БЮЛЛЕТЕНЬ BULLETIN

3522-0000010PЭ

Руководство по эксплуатации
Operator's manual

Бюллетень Bulletin 28-2011 БЭ	МОДЕЛЬ ТРАКТОРА TRACTOR MODELS	БЕЛАРУС-3522 BELARUS-3522
--	-----------------------------------	------------------------------

Рисунок 2.1.1 – Расположение органов управления и приборов трактора

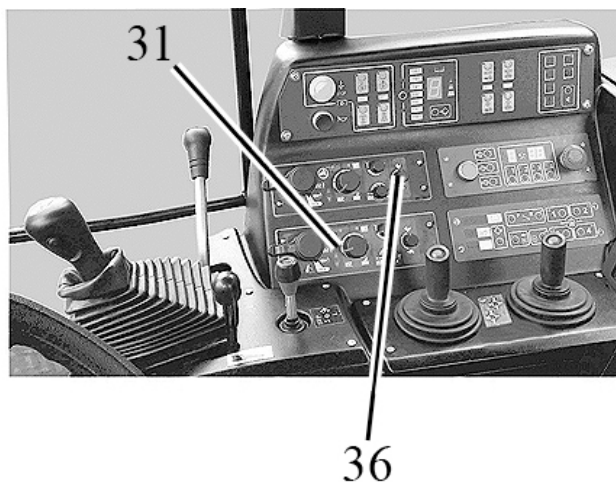
1 В разделе 2 «Органы управления и приборы» в подразделе 2.1 «Расположение органов управления и приборов трактора» изменить линии-выноски позиций на рисунке 2.1.1:

Имеется:

31 – пульт управления передним навесным устройством;

36 – пульт управления задним навесным устройством.

Должно быть:

31 – пульт управления передним навесным устройством;
36 – пульт управления задним навесным устройством.

Figure 2.1.1 – Layout of tractor controls and instruments

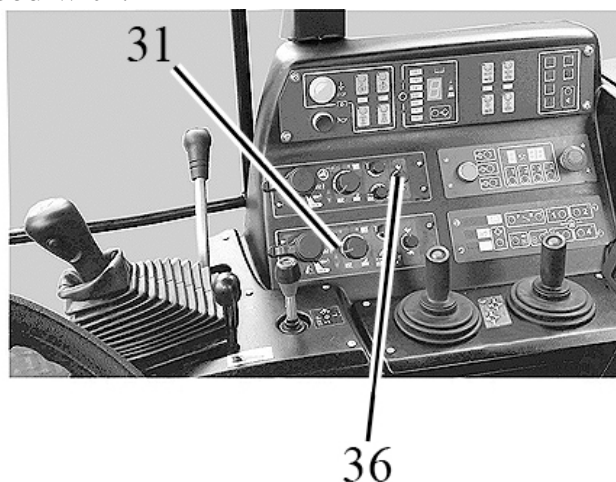
1 In section 2 “Controls and instruments” in subsection 2.1 “Allocation of tractor controls and instruments” position lines are to be changed in figure 2.1.1:

The information available:

31 – front lift linkage control console;
36 – rear lift linkage control console.

Shall be replaced with:

31 – front lift linkage control console;
36 – rear lift linkage control console.
